**Subject: Palo Verde Nuclear Generating Station (PVNGS)
Units 1, 2 and 3
Docket Nos. STN 50-528, 50-529, and 50-530
Response to NRC Request for Additional Information Regarding
PVNGS Units 2 and 3 Steam Generator Tube Inspections**

**ARIZONA PUBLIC SERVICE COMPANY
RESPONSE TO NRC REQUEST FOR ADDITIONAL INFORMATION
REGARDING PVNGS UNITS 2 AND 3 STEAM GENERATOR TUBE
INSPECTIONS**

Figure 1
MRPC Graphic "Abnormal" Dent

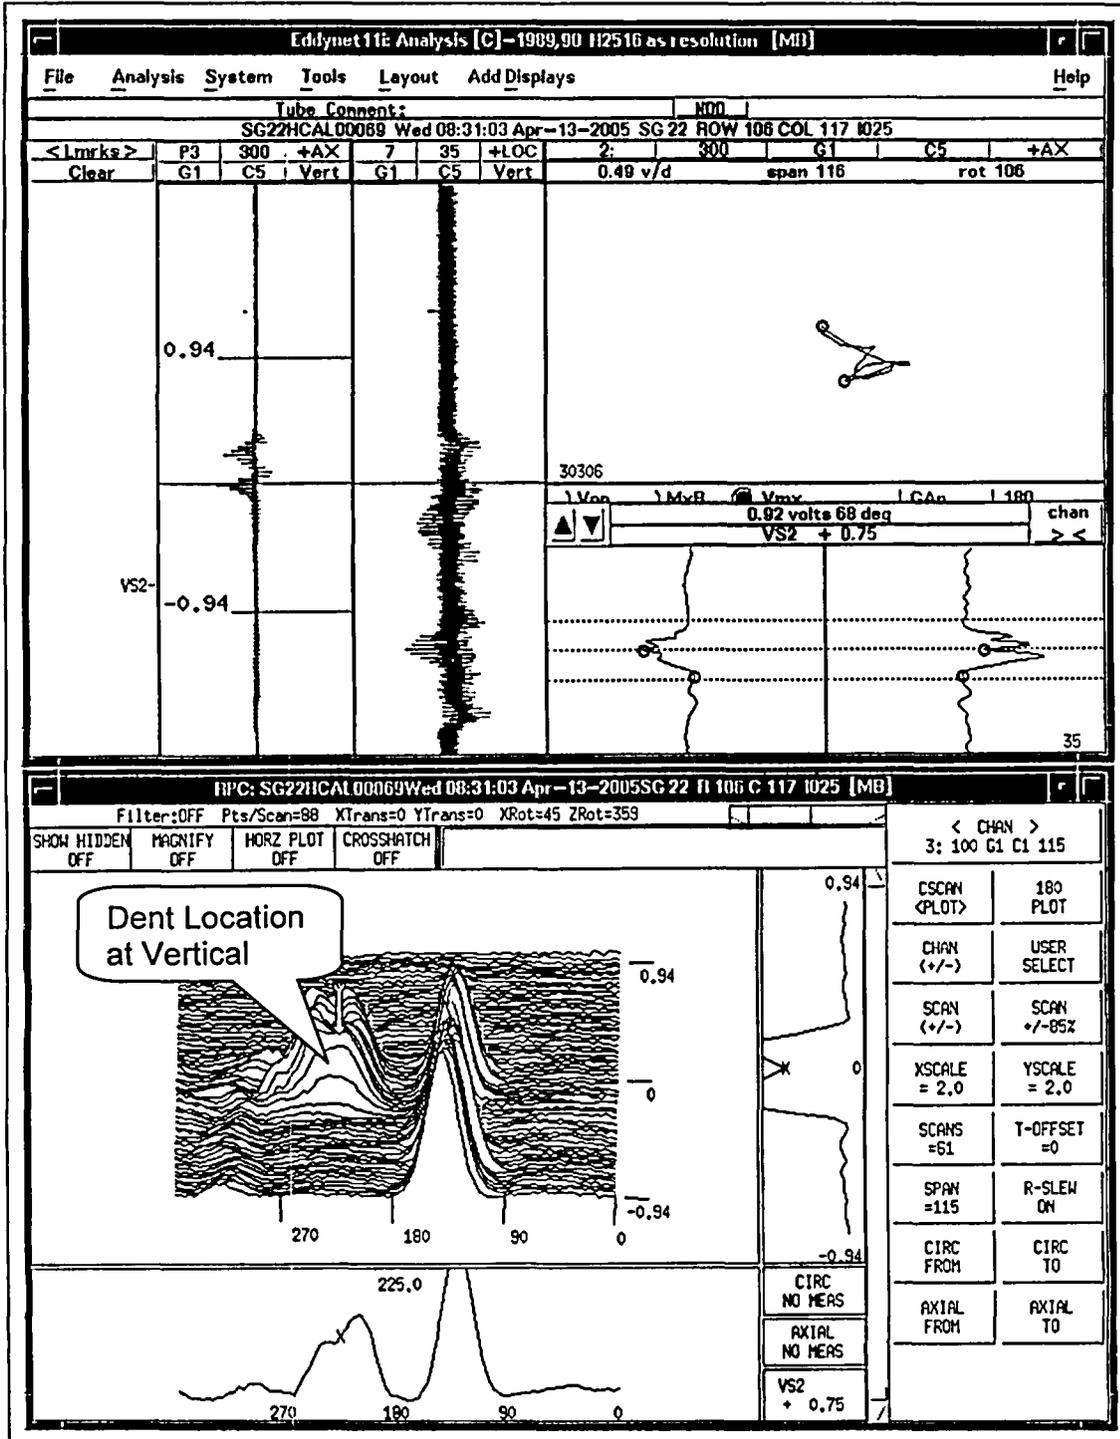
In Section 4.0 of your October 24, 2005 letter, you indicated that for steam generators 21 and 22, tubes were detected with abnormal dent indications. Were these indications present since the pre-service inspection? If so, please discuss whether they have changed since the pre-service inspection and the reasons for any change. If they were not present in the pre-service inspection, please discuss the cause of the dents. Please discuss whether these dents are considered "abnormal" since they are similar to the dent indication that was the cause of your 2004 primary-to-secondary leak.

All of the dent indications listed in Section 4.0 of the October 24, 2005 letter were present during the pre-service examinations (PSE). No changes were noted in any of the dent rotating coil examinations. The source of these abnormal dents was most likely the product of the initial steam generator assembly. All four abnormal dent indications (three in SG 21 and one in SG 22) appear to be directly associated with a vertical strap support bar. Note the NDE graphic in attached Figure 1 which indicates that the location of the rotating coil dent indication is at the vertical strap (VS2).

These dents were considered "abnormal" by APS because they exhibited vertical amplitudes higher than typical dent indications. This condition/classification is one of the lessons learned during the 2004 midcycle (leaker) outage and subsequent dent evaluations. The PVNGS Analysts' Technique Sheet for the +Point examination of dents requires the analysts to record any dent with a vertical amplitude over 0.2 volts with the +Point 300 kHz channel. These are then reviewed by the APS Level III for location, appearance, and the potential for masking of other types of flaw indications.

The abnormal dent indications were similar to the dent indication in SG 21 Row 156 Column 143 that leaked during Cycle 12 in that they had higher vertical voltage than other typical dent indications. Using the +Point 300 kHz channel, the vertical amplitude of the leaking tube was 0.94 volts compared to voltages of 0.29, 0.30, 0.67 and 0.92 for the tubes listed in Section 4.0. As indicated above, the four tubes in U2R12 were associated with a support bar, whereas the dent in the leaking tube was not directly associated with a support bar and the dent in the leaking tube was attributed to damage caused by a packing crate screw.

Although it is unlikely that these dents were caused by crate screw damage, APS took the conservative action and removed the affected tubes from service by plugging.

Figure 2
Set Screw Installation Unit 1 and 2 RSG

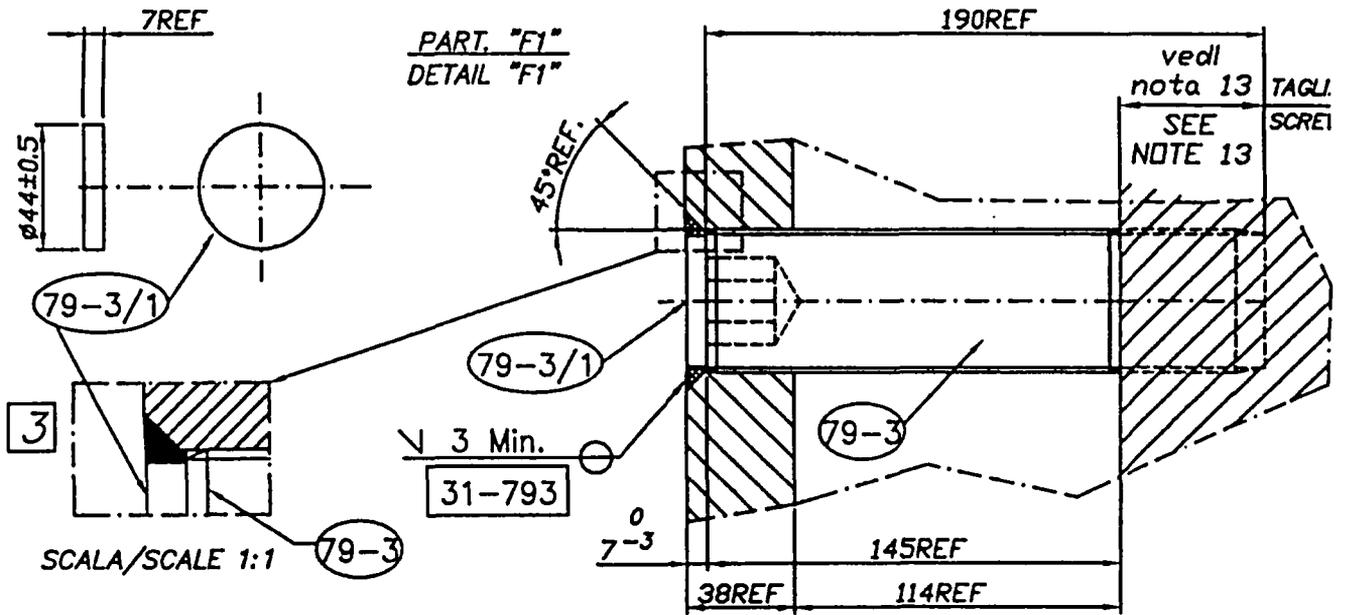
It is the NRC staff's understanding that the Palo Verde, Unit 2, replacement steam generators have an economizer with a similar set screw configuration as that in Unit 3 (which experienced degradation). As a result, please discuss whether any inspections were performed to confirm the integrity of these locations. In addition, please discuss whether any other secondary side inspections were performed during the outage.

The main design differences between the original steam generators (OSGs) and RSGs with respect to the feedwater box include; the set screw length exposed to feedwater flow, the gap setting against the shell and the set screw installation technique. The difference in set screw material (SAE Gr.5 vs. SA-193 Gr. B7) was not judged to be a significant difference.

The increased set screw length exposed to feedwater flow was evaluated with respect to the possible negative effect of increased flow forces on the set screw. The increased force on the set screw was calculated to negligibly increase by approximately 3% in the RSGs. Alternatively, the increased length permitted setting the gap between the set screw and the shell at 0.06 inches in the RSGs vs. 0.25 inches in the OSGs. This was evaluated to have a positive effect during accident

conditions. Although not likely to help limit the erosion or wear of the feedwater box at the set screw location, if erosion does occur, the combination of the smaller gap and the seal plate on tube side of the feedwater box would limit the movement of the set screw. As a result, it is less likely that the same amount of erosion as seen in the Unit 3 OSGs would lead to a set screw failure.

The most significant difference between the OSGs and the Unit 1 and 2 RSGs is the installation of a seal plate. In the OSGs the set screws were welded to the tube-side face of the feedwater box then ground flush. Because of the hardness of the set screw material, very little of the weld metal adhered to the set screw. As a result, there was a small leak path through the threads that allowed water to leak from the feedwater box to the economizer region of the steam generator. Conversely, the Units 1 and 2 RSGs have a 0.25-inch carbon steel plate that is groove-welded flush to the tube-side face of the feedwater box (see attached Figure 2). This seal plate is a significant design improvement in the RSGs. Although the primary purpose of the seal plate was to avoid welding to hardened bolting material, it has the secondary effect of eliminating the jetting flow through the set screw hole if the set screw falls out. While this change might not significantly affect the probability of a set screw failure in Units 1 and 2, it will have a significant effect on the consequences of a failure.

Based on this evaluation, APS concluded that the probability of a set screw failure is marginally lower in the Unit 1 and 2 RSGs than in the OSGs. It should be noted that the erosion/corrosion that led to the set screw failure in the Unit 3 OSG occurred after 11 operating cycles. As such, the mechanism is not considered to be a near term issue. To ensure that the condition does not manifest itself in the Units 1 and 2 RSGs, a routine Preventative Maintenance Task to inspect the RSGs in this region on a 6Y (six year) frequency has been implemented for Units 1 and 2, and the condition has been incorporated into the PVNGS Degradation Assessment.
